NEW MEXICO
ENVIRONMENT DEPARTMENT

Hazardous Waste Bureau

**RE: SECOND NOTICE OF DISAPPROVAL
RCRA FACILITY INVESTIGATION
WORK PLAN FOR PARCEL 6
FORT WINGATE DEPOT ACTIVITY
EPA ID# NM6213820974
FWDA-08-001**

The New Mexico Environment Department (NMED) received the Department of the Army's (the Permittee) *Resource Conservation and Recovery Act (RCRA) Facility Investigation Work Plan for Parcel 6 (Revised)*, dated April 30, 2010 (Work Plan) and submitted pursuant to Section VII.H of the Fort Wingate Hazardous Waste Facility Permit. NMED has reviewed the Work Plan and hereby issues this second Notice of Disapproval (NOD). The Permittee must address the following comments in a revised Work Plan.

Figure 8-5
Airborne Geophysical Survey of SWMU 20
Fort Wingate Depot Activity, New Mexico

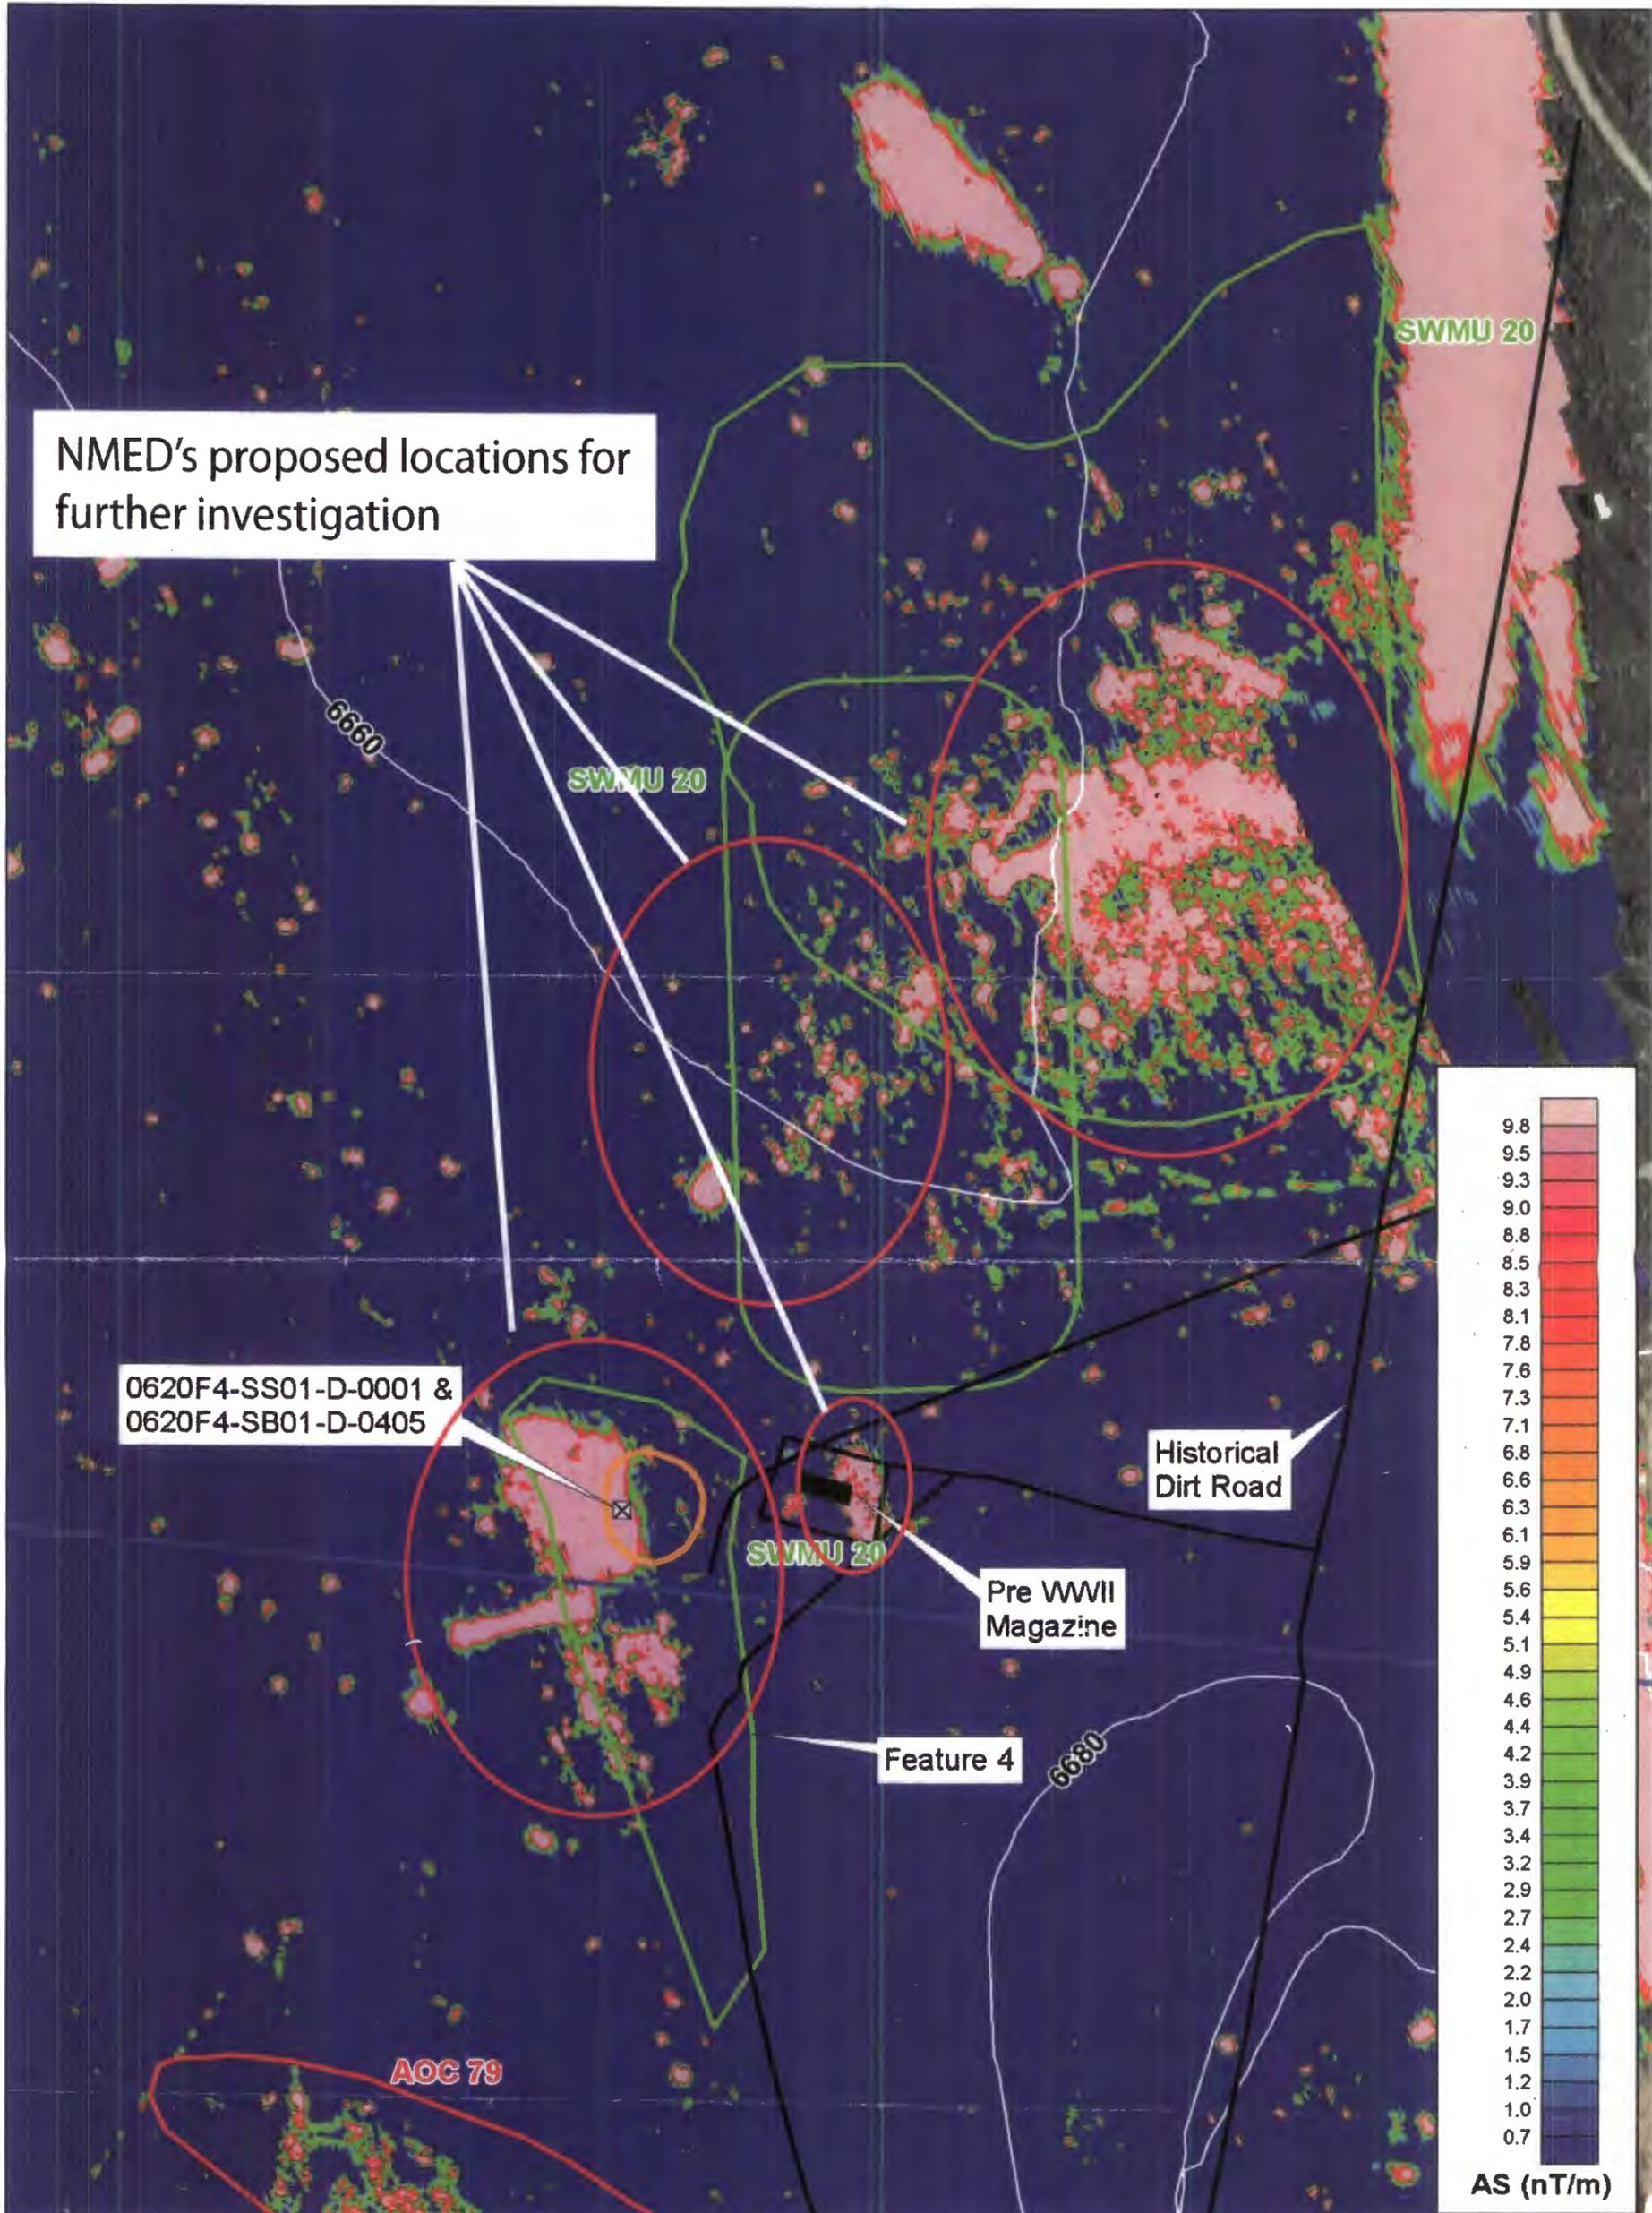
In Section 8.3.2 (Media Characterization), page 8-14, the Permittee states “[i]n January, 2009, a low altitude airborne vertical magnetic gradient geophysical survey was conducted over the Fort Wingate Army Depot, New Mexico.” The Permittee also states that “[t]he results of the airborne geophysical survey for SWMU 20 are shown in Figure 8-5.” Based on the results shown in Figure 8-5, it appears that many geophysical anomalies were not investigated or removed throughout SWMU 20. With the exception of the railroad classification yard and SWMU 25, the Permittee must therefore identify and remove all waste associated with geophysical anomalies at the locations identified by NMED in the attached Figure 8-5. The Permittee must also determine whether hazardous constituents have been released to the environment. The waste must also be profiled for proper disposal. The Permittee must revise the Work Plan to include the proposed characterization and removal actions.
